Extra Class License Manual – Supplemental Information and Errata

The following text is intended to support or correct the 12th edition of the *Extra Class License Manual* and the 5th edition of the *Extra Class Q&A*. Recent changes in this version of the document are in red.

Chapter 9

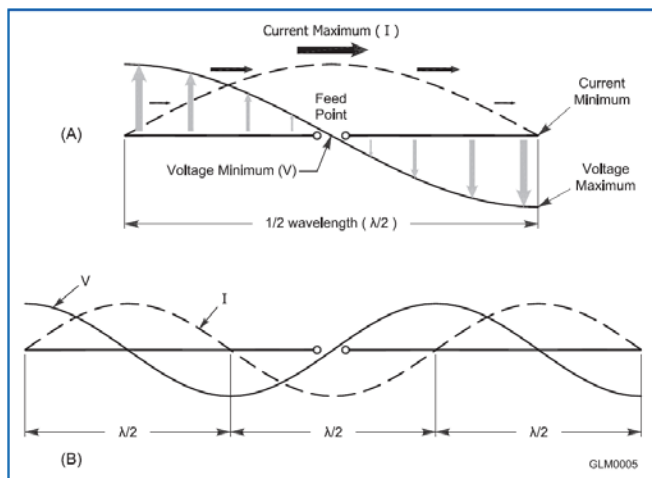
A resonant antenna has a feed point impedance that is all resistance. i.e. $Z = R + j0$. Yet the current and voltage appear to be 90 degrees out of phase at resonance – why?

The drawing above shows the current and voltage distributions. The distributions along the wire are just the magnitude of the waveforms (like the envelope of a modulated signal) and doesn't say anything about the phase of the actual waveform. It is the distributions that are 90 degrees out of phase, not the waveforms. At the center, the voltage waveform reaches a minimum while the current waveform is at a maximum - yet both waveforms are in-phase (at resonance), resulting in a purely resistive impedance.
